orbit_demo review notes: issues, trade-offs, questions, discrepancy register

Package section 09_review_notes of orbit_demo_design_review, written 2026-10-06. Links are relative to this file. Paths in backticks without a link (reports/..., build/..., site/..., viz/..., docs/research/..., ORFS image paths) are repository, build or tool-image paths in /home/user/chip that are not copied into the package, unless a package copy is linked next to them or listed in [README.md](#) under How the package was built. "repo" = /home/user/chip.

Item	Revision / identifier	Note
Design	orbit_demo (ORBIT-AI 4-lane INT8 digital demonstrator)	top module orbit_demo, LANES=4
RTL	rtl/orbit_demo.v, orbit_mac_lane.v, orbit_thermal_tmr.v, orbit_keep_reg.v at git commit 26566f0 (2026-09-29 18:54 UTC); unchanged through the package commit	sha256 a3fffb22... / efef3d33... / bba77a5a... / ea05bdc1... (full hashes in MANIFEST.sha256 at the package root)
Specification	docs/SPEC.md at 26566f0 (never revised)	sha256 aef5d9fb...
Concept brief	docs/orbit-ai-design-brief.pdf, "ORBIT-AI v0.1, 29 September 2026" (never revised; describes an earlier project state, see discrepancy register)	sha256 9d5f33d3...
Reviewed l

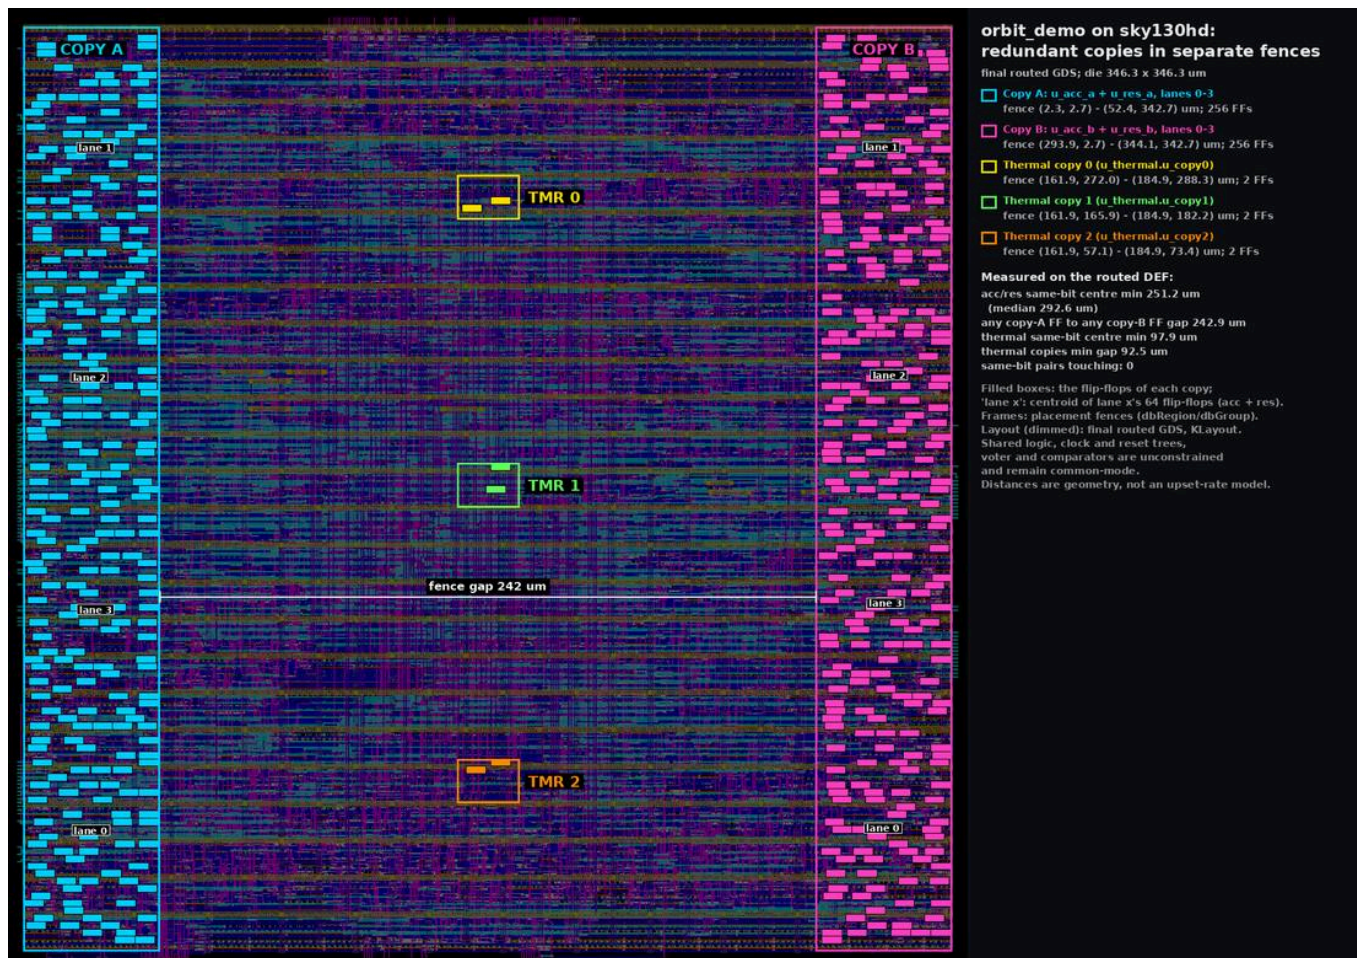
Figure 1. Routed sep GDS (KLayout render by `scripts/pdsep_render.py`, published as [orbit_demo_sky130hd_sep.png](#)). Copy A and copy B fences at the die edges, thermal fences TMR 0-2 in the centre column. Everything between the fences (multipliers, adders, comparators, OR-tree, voter, clock and reset trees) is shared (K-02). The "fence gap 242 um" label rounds the measured 241.50 um (D-13). Status: VERIFIED.
